WAIAWA INTERCHANGE

STRUCTURE 16

LAYOUT PLAN
& LONGITUDINAL SECTION

WAIAWA INTERCHANGE
F.A.I. Proj. No. I-HI-1 (75):8

STATE OF HAWAII DEPARTMENT OF TRANSPORTATION HIGHWAYS DIVISION
STRUCTURE N° 15 & 16 INTERSECTION CONC. BARRIER DETAILS WAIAWA INTERCHANGE F.A.I. PROJ. N° I-HI-1(75)-8 Scale as shown Date: June, 1971
SHEET No. 12C OF 13 SHEETS

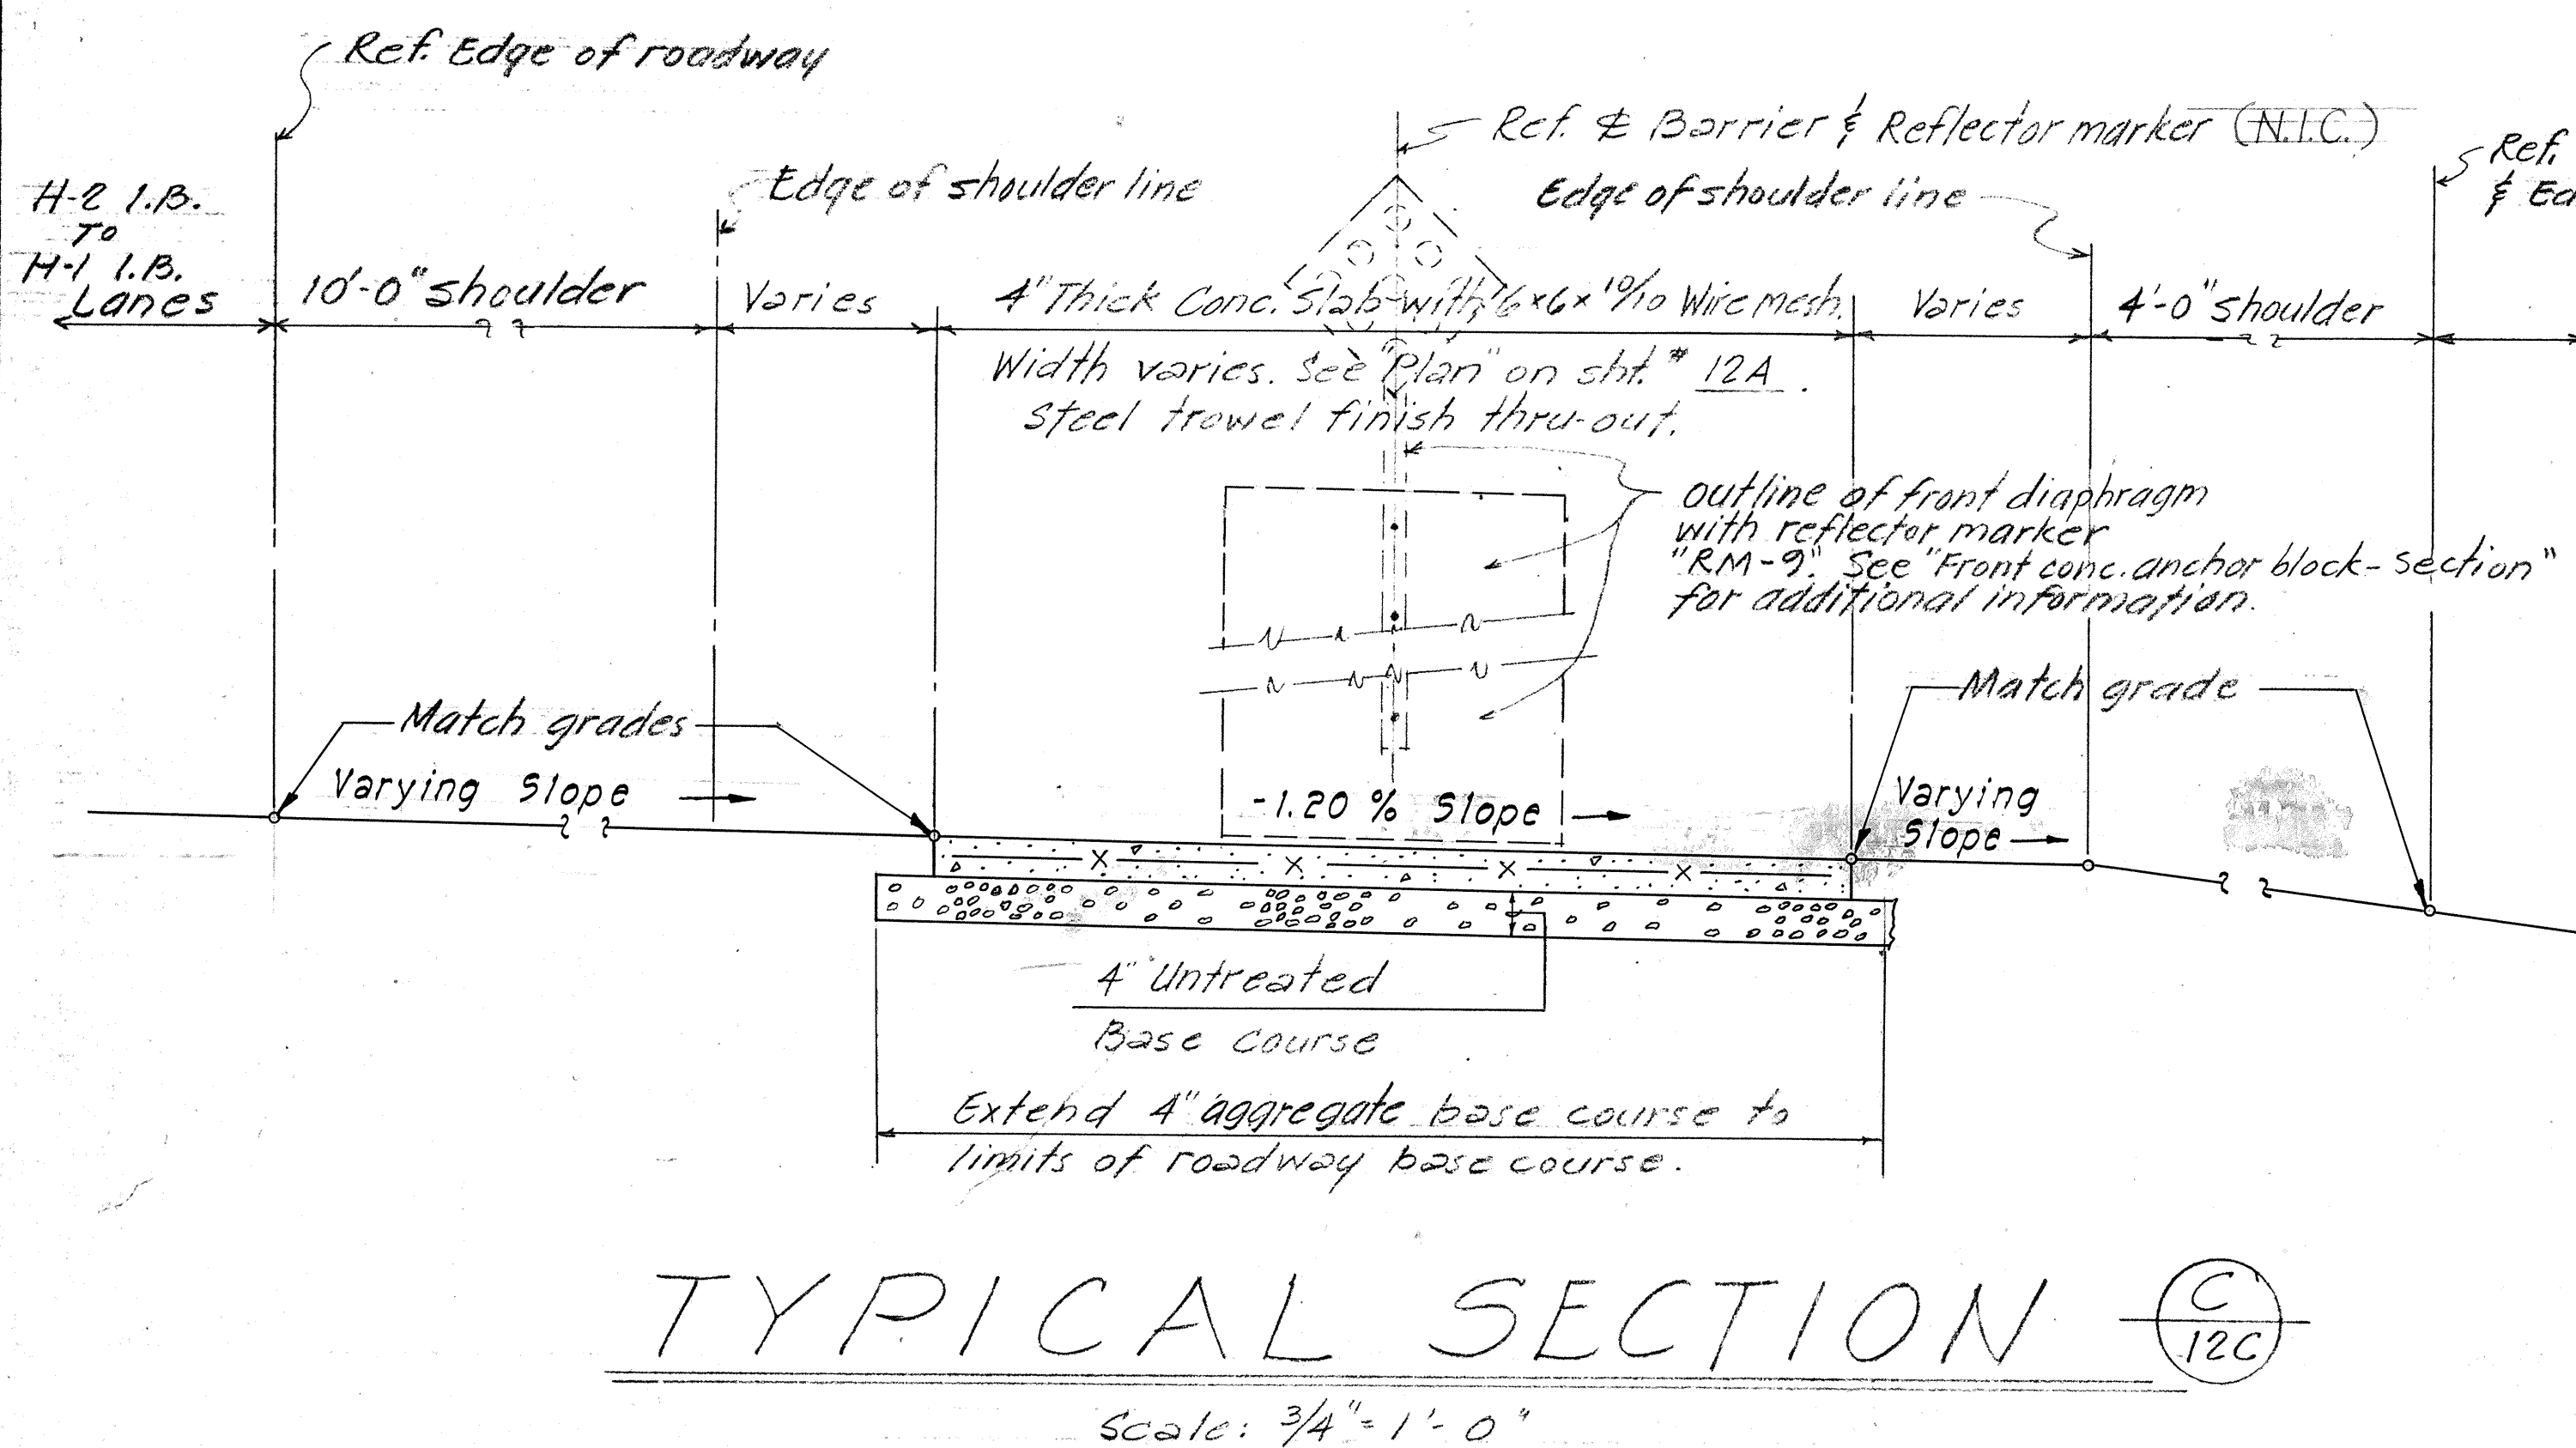
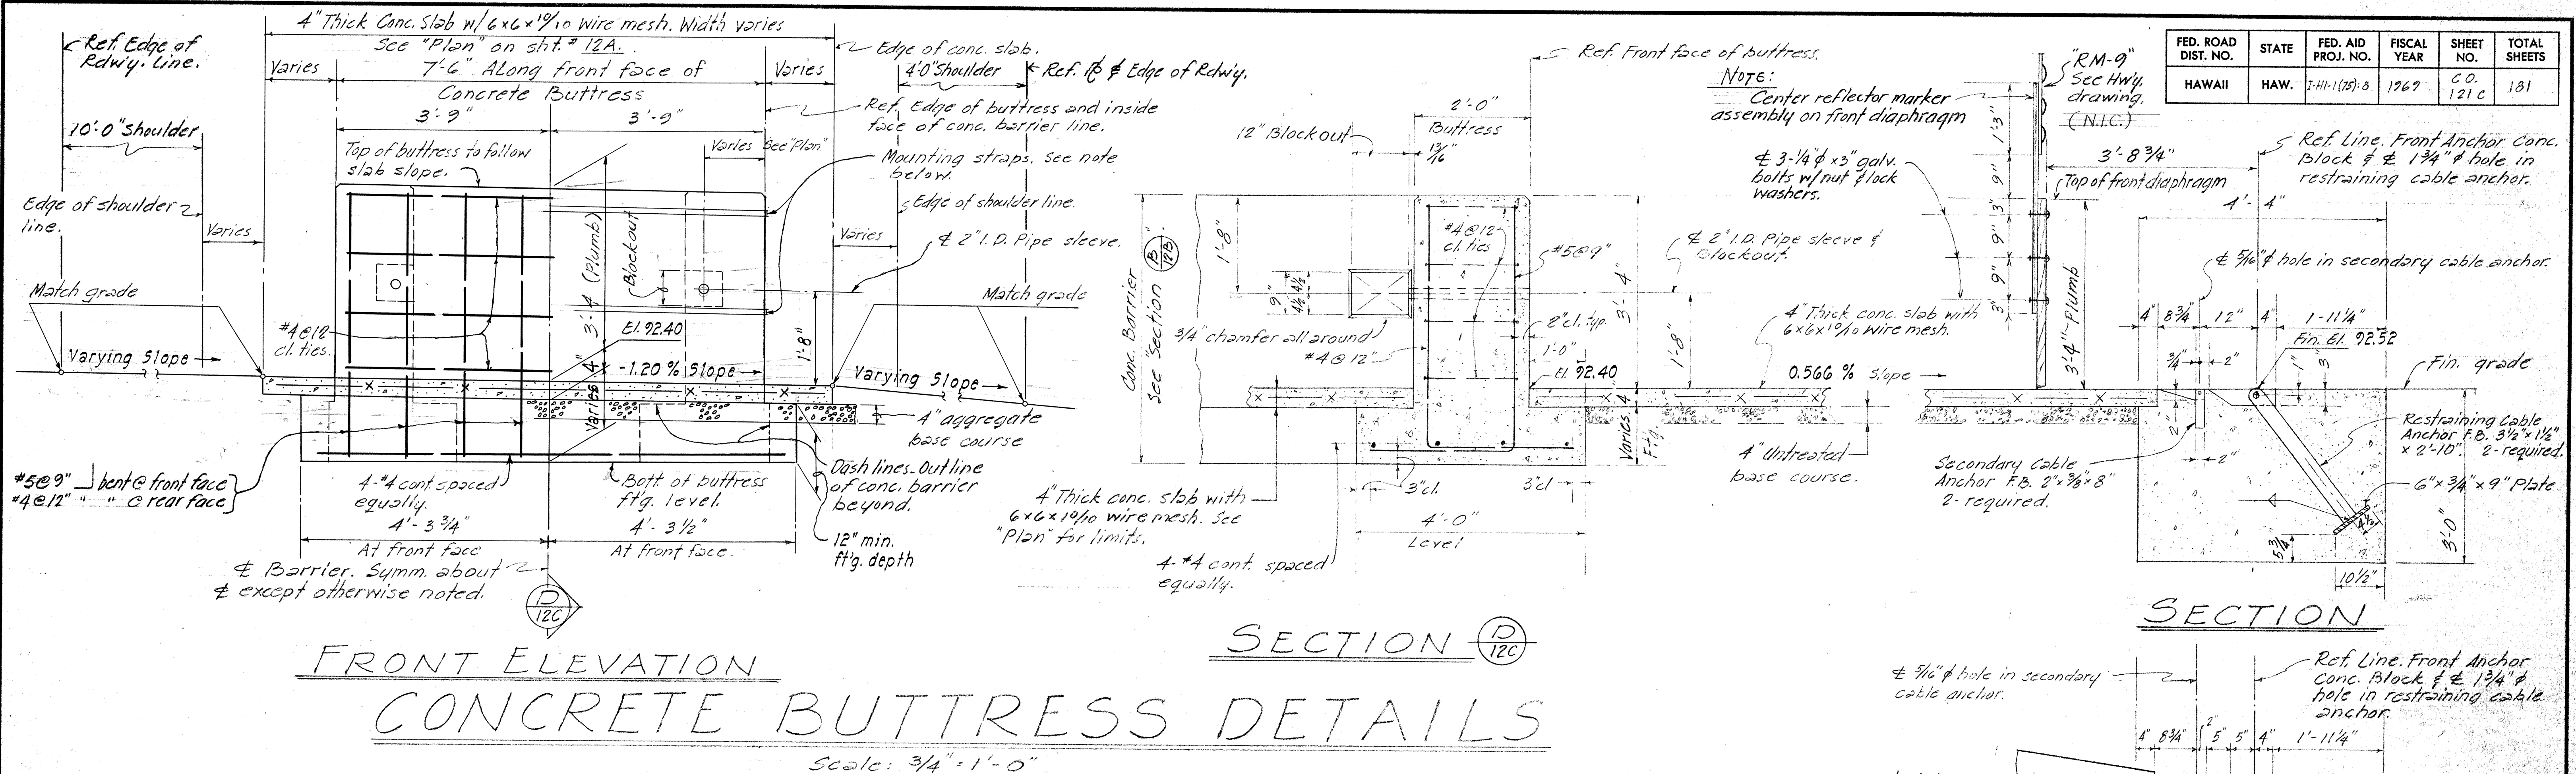
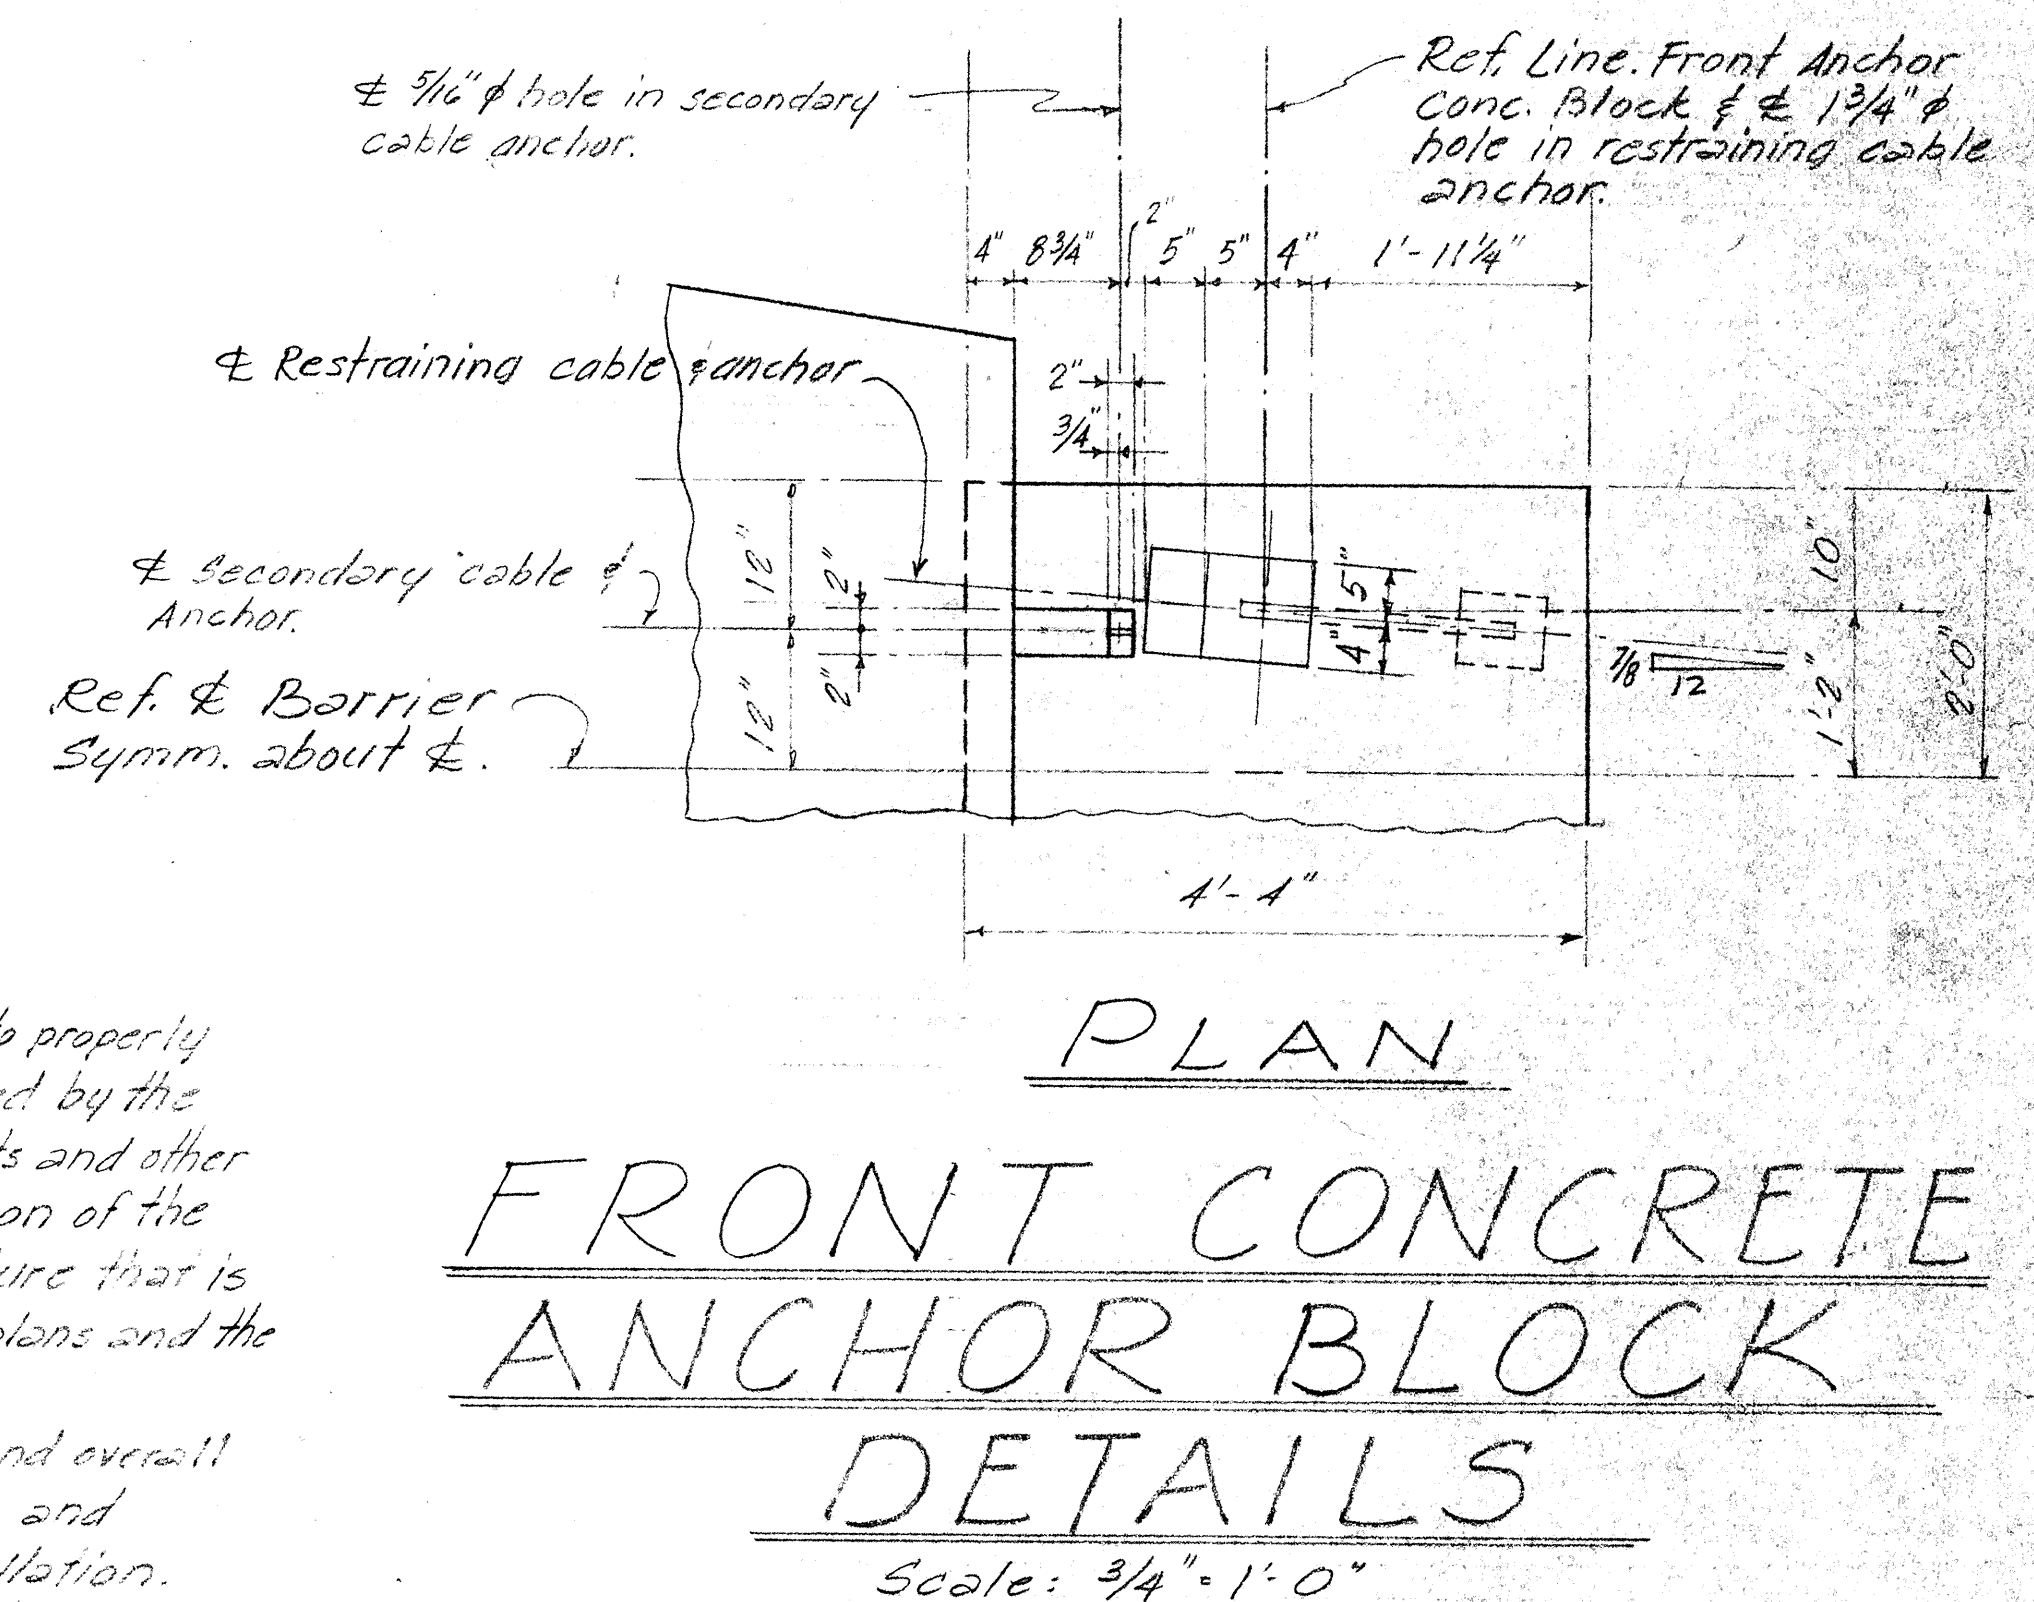
DATE	REVISION
4-18-73	Cushion barrier conc. structure grades revised to match revised Highway grades. Also detail drawing of reflector marker RM-9 added.
6-24-71	Abut wingwalls #1 & #4 realigned due to addition of cushion barrier conc. structure.
